Responses to NRC July 5 Questions and July 7, 2022 Call

Figure 6 – L1-SUB-TDS B RASS Sample Locations

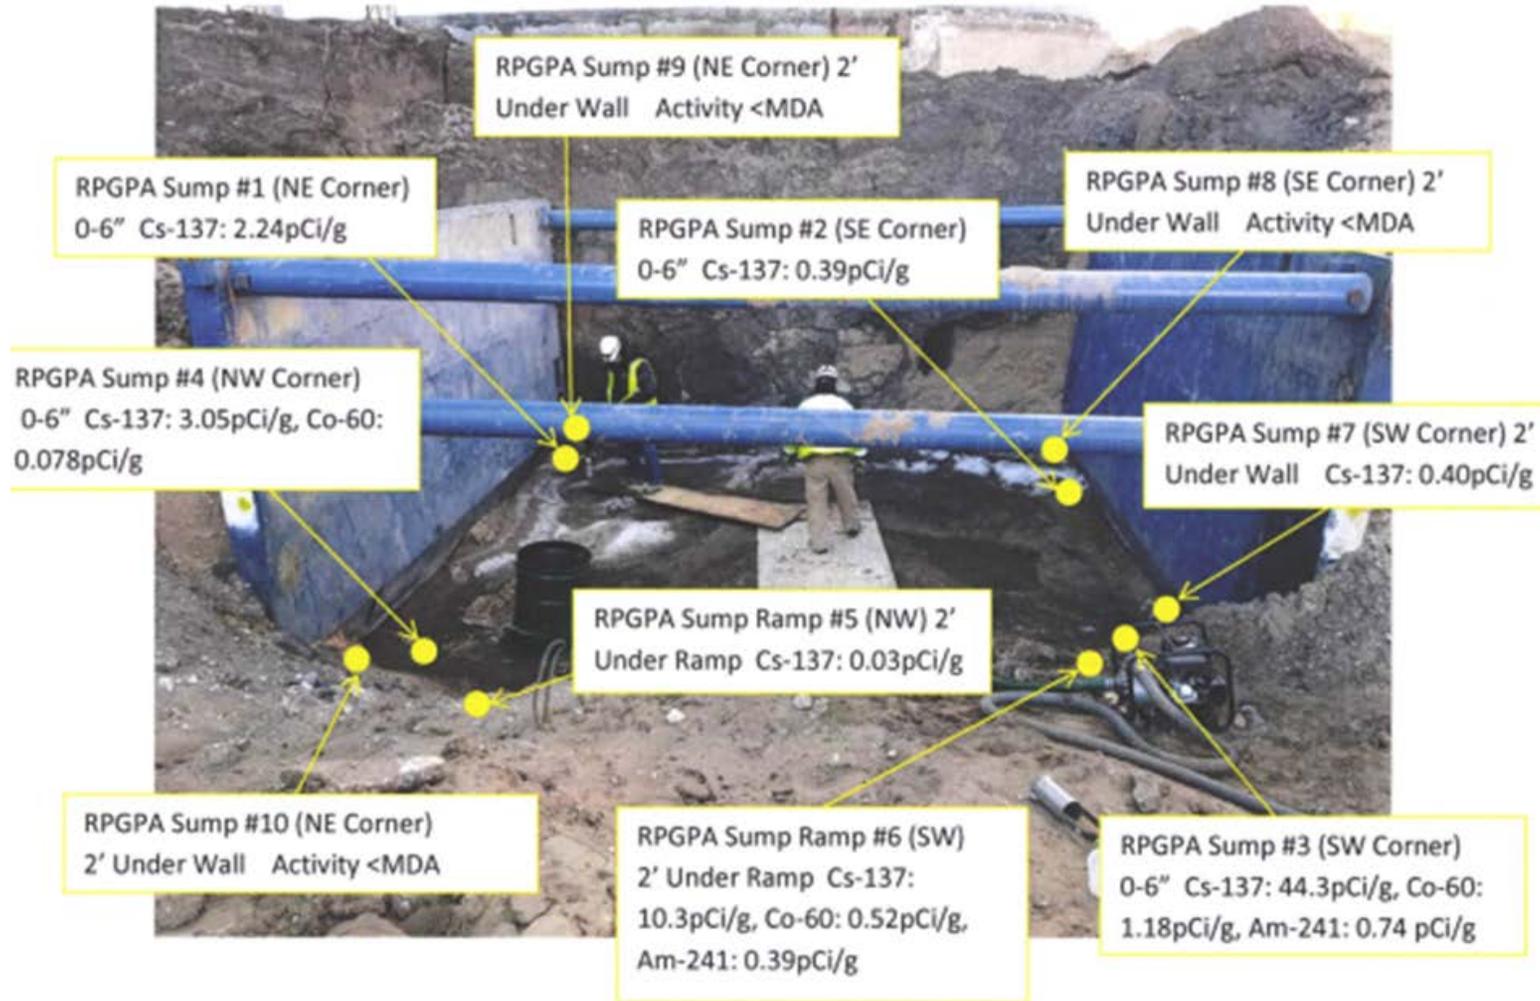
L1-SUB-TDS B. For the RPGPA Excavation continuing characterization samples and RASS samples, please provide the location of where the samples were taken. Provide a map with the continuing characterization and RASS sample locations (in Figure 16-1 or a new Figure 16-2).

The two figures below show the sample locations for the RASS performed in L1-SUB-TDS B.
